2.5L 200 OptiMax SportJet Air Compressor Reed Failure

2.5L 200 OptiMax SportJet Air Compressor Reed Failure

Air compressor

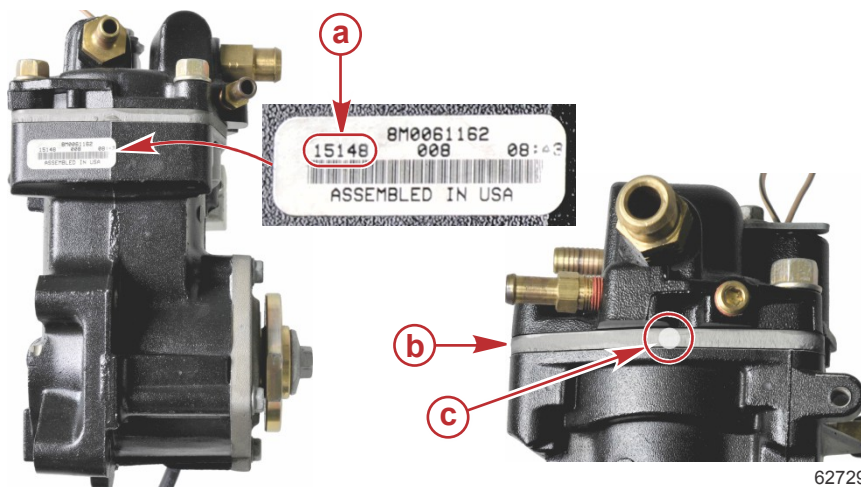
IMPORTANT: A white dot on the edge of the reed plate assembly indicates the reed plate assembly has been replaced. Do not rework a compressor with a white dot on the edge of the reed plate assembly.

Check the engine to confirm whether the air compressor is an affected unit. If no white dot is present and the engine serial number falls within the range specified at the top of this service bulletin, replace the reed plate assembly.

Inspect all in-stock replacement air compressors. If no white dot is present and the Julian date code falls between 14189 (July 8, 2014) and 16246 (September 2, 2016), inclusive, replace the reed plate assembly.

Reed plate assembly edge marked with a white dot

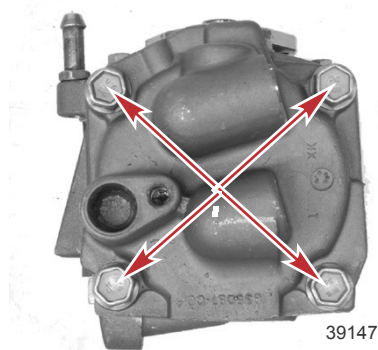
- To indicate that the rework procedure has been completed, mark the top edge of the replacement reed plate assembly with a white dot.

- When installing the cylinder head, tighten the four cylinder head screws in a cross pattern to the specified torque.

Description	Nm	lb-in.	lb-ft
Cylinder head screws	27	–	20
